# Change to elastic V-ribbed belt

## Tensioner pulley 531 0503 10 is no longer needed

Engine: F1AE

Fig. 1: Accessory drive up to Engine No. 0113089 with tensioner pulley

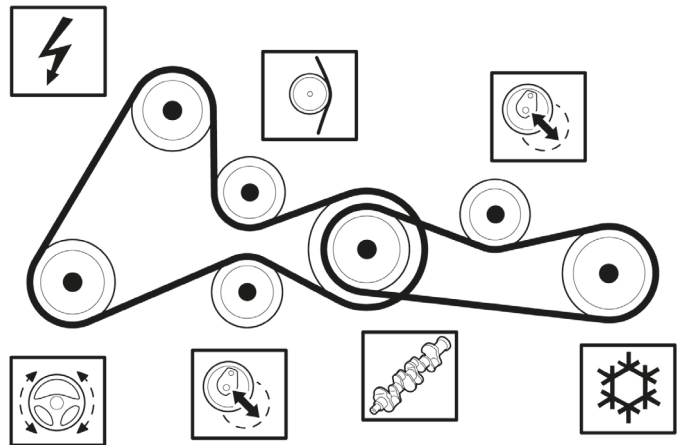
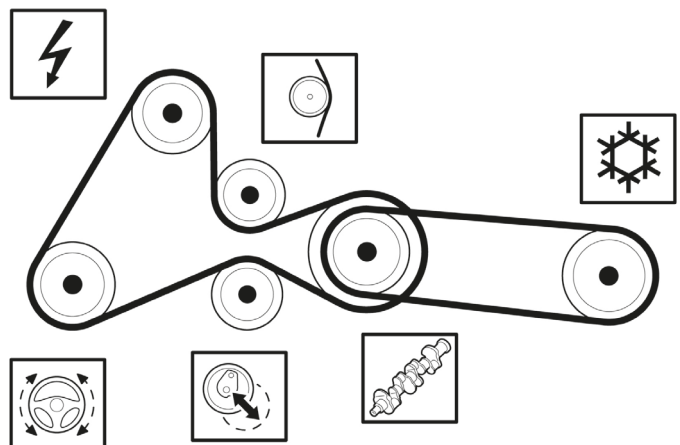
For the accessories drive system of the air conditioning compressor, the manufacturers listed above use an elastic V-ribbed belt starting from Engine No. 0113090. This eliminates the tensioner pulley previously required with the conventional V-ribbed belt.

Engines up to Engine No. 0113089 can also be equipped with the elastic V-ribbed belt FB4EPK903 during preventive maintenance. This, too, eliminates the need for the tensioner pulley.

The elastic V-ribbed belt meets all technical specifications without restriction and can also be safely installed on engines up to Engine No. 0113089. Once an engine has been converted to an elastic V-ribbed belt, a tensioner pulley can no longer be installed under any circumstances.
